Access Compliance Report

Public Rights-of-Way

Intersection ID: 42945	Main Street: MOONDANCE_LN	Cross Street: SONOMA_VALLEY_DR	Location: NE
ADA ID: 1D1AF8EBF2CF	Ramp Type: PerpDiag	Initial Pass/Fail: Fail	Overall Compliance: No
		Severity Score: 22.5

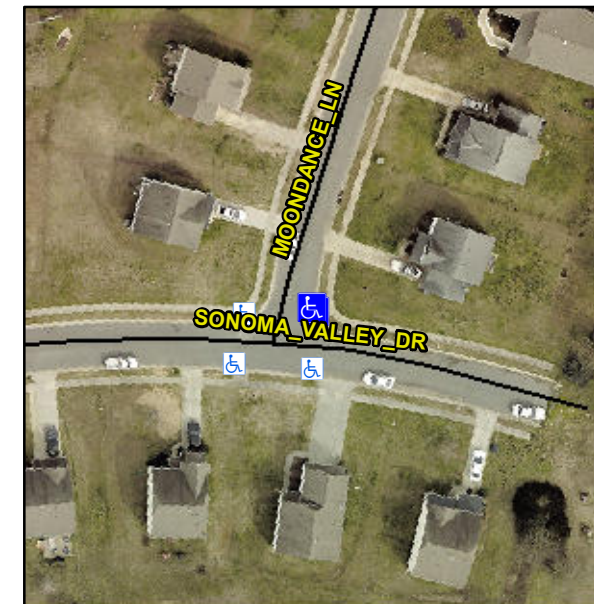
Not Found, R304.5.1, R304.2.2, R304.5.3

Compliance	Description	Data	Compliance	Description	Data
N/A	Ramp Length (in)	48.0	No	Ramp Slope (%)	8.6
No	Ramp Width (in)	44.0	No	Ramp XSlope (%)	3.2
N/A	Flare Type LT	N/A	N/A	Flare Type RT	N/A
N/A	Flare Slope LT (%)	N/A	N/A	Flare Slope RT (%)	N/A
N/A	Flare Traversable LT?	N/A	N/A	Flare Traversable RT?	N/A
N/A	Landing Length (in)	N/A	N/A	DWS Provided?	N/A
N/A	Landing Width (in)	N/A	N/A	DWS Contrast?	N/A
N/A	Landing Slope (%)	N/A	N/A	DWS Length (in)	N/A
N/A	Landing X Slope (%)	N/A	N/A	DWS Full Width?	N/A
N/A	Landing Curb? (Y/N)	N/A	N/A	DWS Offset (in)	N/A
N/A	Shared Landing?	N/A			
N/A	Gutter Ponding?	N/A	N/A	Gutter Slope (%)	N/A
N/A	Gutter Lip Ht (in)	N/A	N/A	Gutter X Slope (%)	N/A
N/A	Painted X Walk1?	No	N/A	Painted X Walk2?	No
	X Walk 1 Direction	To W		X Walk 2 Direction	To S
N/A	X Walk 1 Width (in)	N/A	N/A	X Walk 2 Width (in)	N/A
	X Walk 1 Slope (%)	0.8		X Walk 2 Slope (%)	4.0
	X Walk 1 X Slope (%)	4.0		X Walk 2 X Slope (%)	0.6

Remove & Replace Curb Ramp With Two New Directional Ramps or Equivalent.
